18 April 2024

Subject: Review comments on engineering:
Solid Waste Permit Application – GSL Landfill, Dalton and Bethlehem,
New Hampshire

Figure from Reference 1. (Black lines and arrows added)

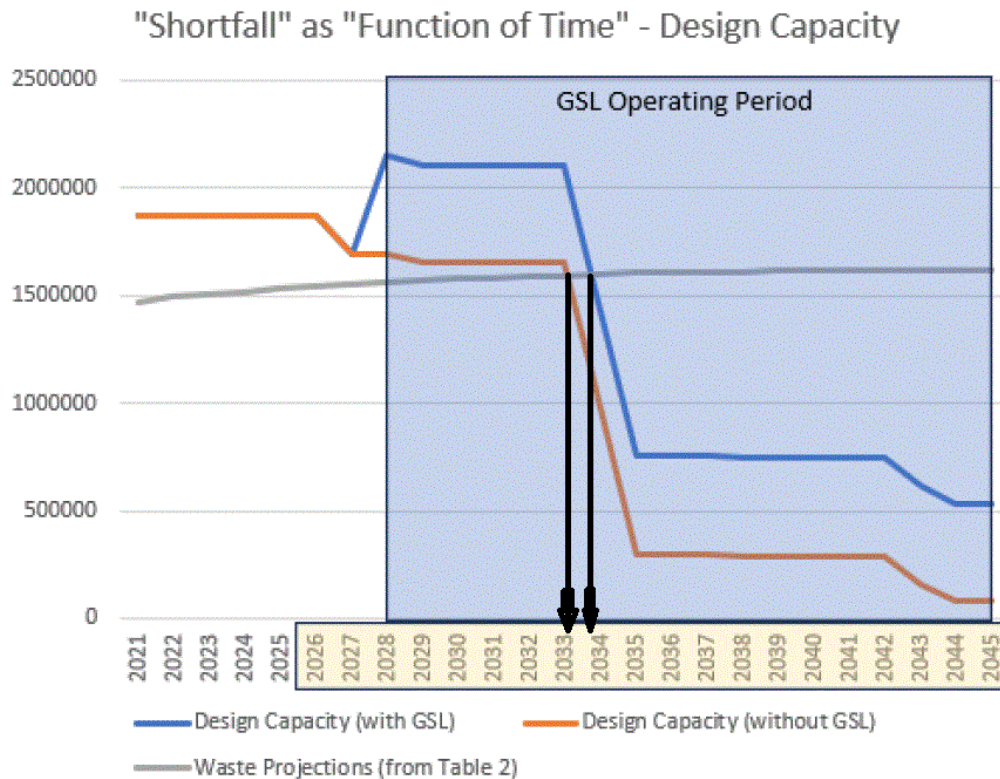
In my professional opinion, this graph does not support the premise that permitting GSL will help with the design capacity. When the two plots of design capacity as a function of time are compared (blue line – with GSL and red line – without GSL), there is an addition of capacity between 2028 and 2033, i.e., the blue line is above the red line. However, the capacity decreases precipitously when NCES closes and both lines drop sharply between roughly 2033 and 2035. The rates of drop (i.e., the slopes of the blue and the red lines) between 2033 and 2035 are almost identical.

The gray line represents the waste projection (i.e., generation). When this line is below the red-line or the blue-line, it means that the amount of waste produced or generated is smaller than the design capacity available in the landfills, i.e., there is space to accommodate the waste material.

The cross-over point, when the waste projection (gray) line crosses the capacity line, represents the instant of time when capacity runs out, after which the generation becomes higher than capacity (gray line is above). By inspecting the graphs, one can see that the gray line (waste projection) crosses both the blue line (design capacity with GSL) and the red line (design capacity without GSL) between 2033 and 2034, i.e., within less than a year of each other. That means the availability of GSL would help move the date when waste capacity runs out by *less than one year*. That is to say, without GSL, the capacity would run out at the beginning of 2033 and with GSL it would run out towards the end of 2033 (note the two arrows added in the figure).

As permitting this landfill would only move the date when New Hampshire runs out of waste disposal capacity by less than one year, it calls into question the reasonableness of the argument that permitting this landfill would provide a *substantial* public benefit.
